STAFF REPORT
COMMUNITY DEVELOPMENT DEPARTMENT

HEARING DATE: May 18, 2023
 TO: Planning & Zoning Commission
 FROM: Stacy Hersh, Associate Planner
 208-884-5533
 SUBJECT: H-2023-0020 – Dutch Bros at Ten Mile CUP
 LOCATION: 320 & 330 S. Ten Mile Road in the NE ¼ of the Northwest ¼ of Section 14, Township 3N., Range 1W. (Parcels #R8483010020 & R8483010030)

A. Site Plan (date: 9/20/22)

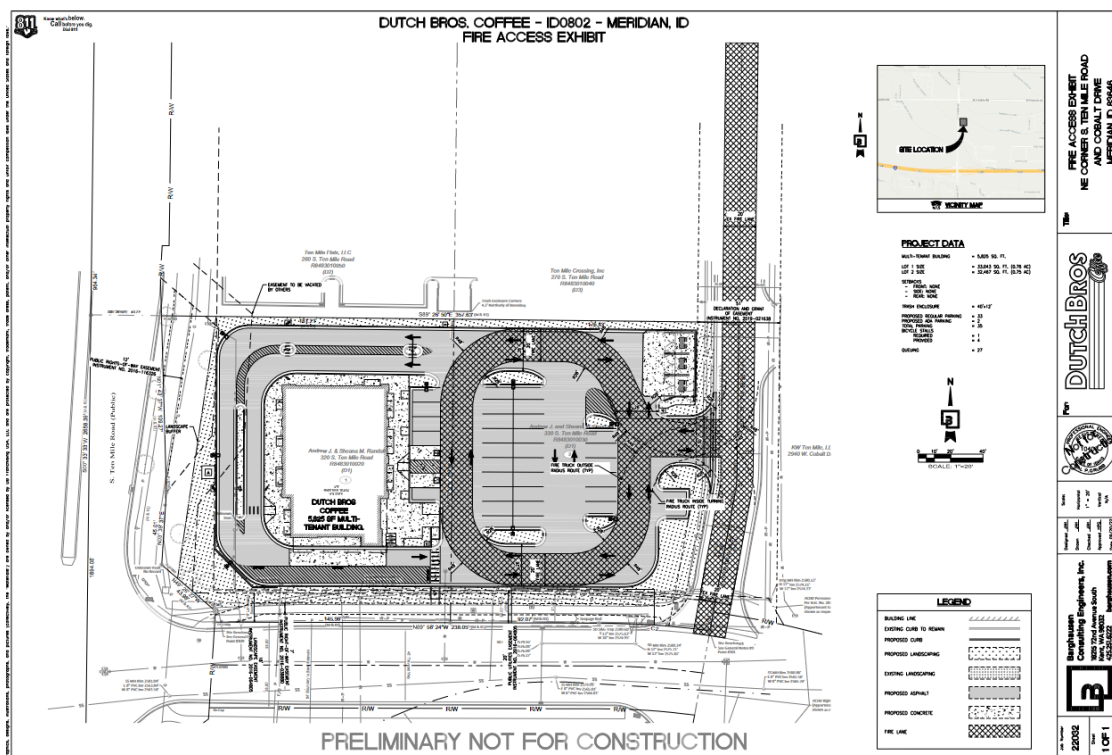
The stacking lane exceeds 100' in length and an escape lane is required. An escape lane is proposed prior to approaching the ordering window on the southwest side of the building (see paint striping on site plan).

Street buffer: The street buffer along S. Ten Mile Road and W. Cobalt Drive was constructed with the improvements for the Ten Mile Creek Subdivision No. 1 for the common area site improvements. ***Staff recommends that the existing landscaping buffers along S. Ten Mile Road and W. Cobalt Drive remain in place and shall be protected during construction on the site per UDC 11-3B-10. According to UDC Table 11-2B-3, a 25-foot wide landscaped buffer is required adjacent to residential uses. However, in this case, the property lines meet in the middle of the drive aisle, meaning that the use is not contiguous to the residential property. Additionally, the adjacent residential use has already incorporated a landscape buffer, sidewalk, and garages lining the private drive, which provides additional screening and buffering.*** Parking lot: Landscaping is required in the parking lot per the standards in UDC 11-3B-8C.1. ***Staff recommends that a landscape strip be added on the east side of the parking lot, in front of the parking stalls, with a width of 3 to 4 feet. This will prevent vehicles from cutting through the parking lot.***

To accommodate the landscape strip, the parking stalls adjacent to the building can be reduced to 17 feet in length and the drive aisles can be reduced to 25 feet in width (see landscape plan below). The Perimeter landscape planter around the building drive aisles (north, south, east, and west) should be 5-feet in width. Per UDC 11-3B-8C.2d, each interior planter that serves a double row of parking spaces shall have at least two (2) trees and shall be covered with low shrubs, lawn, or other vegetative ground cover. Trees shall be centered within the planters and provide urban canopy. Deciduous urban canopy trees shall be pruned to a minimum height of eight (8) feet above the adjacent parking areas.

To meet the UDC requirements mentioned above, the landscape plan should be updated in the CZC submittal to show an additional tree in the two planters that serve the double row of parking stalls.

- c. The perimeter landscape planter surrounding the building's drive aisles (north, south, east, and west) must have a width of 5 feet, as required by UDC [11-3B-8C.1](#).

- d. Add an additional landscape strip to the east side of the parking lot, in front of the parking stalls; the strip shall be 3 to 4 feet in width.
 - e. Depict two additional trees in the planters serving the double row of parking stalls in accord with UDC [11-3B-8C.2d](#).

- f. Depict signage ahead of each pedestrian crossing in the drive-through lane notifying drivers to watch out for pedestrians.
 - g. Submit a detail of the bike rack with the Certificate of Zoning Compliance Application.

C. Dutch Bros. Coffee Proposed Elevations

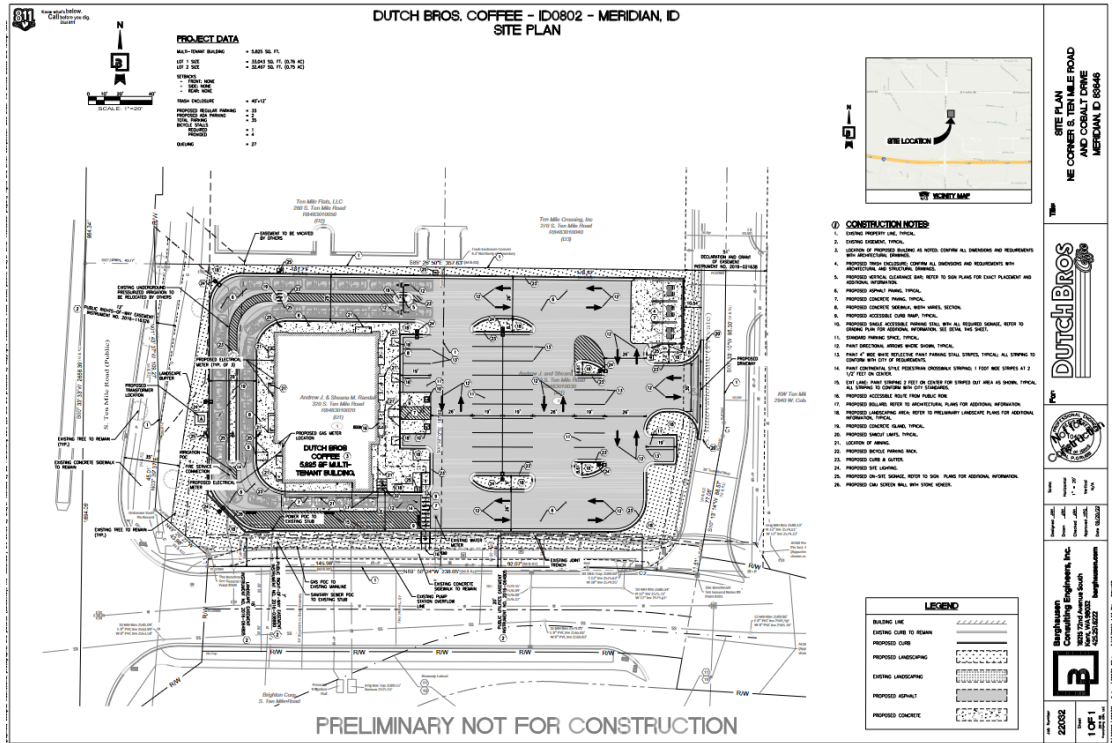
Conceptual building elevations were submitted for the proposed structure as shown in Section VII.C. Building materials consist of fiber cement siding, stucco, metal roofing, stone veneer in Eldorado stone, canopy soffit in natural north-western spruce, and glazing. Final design is required to comply with the adopted TM Crossing Design Guidelines.
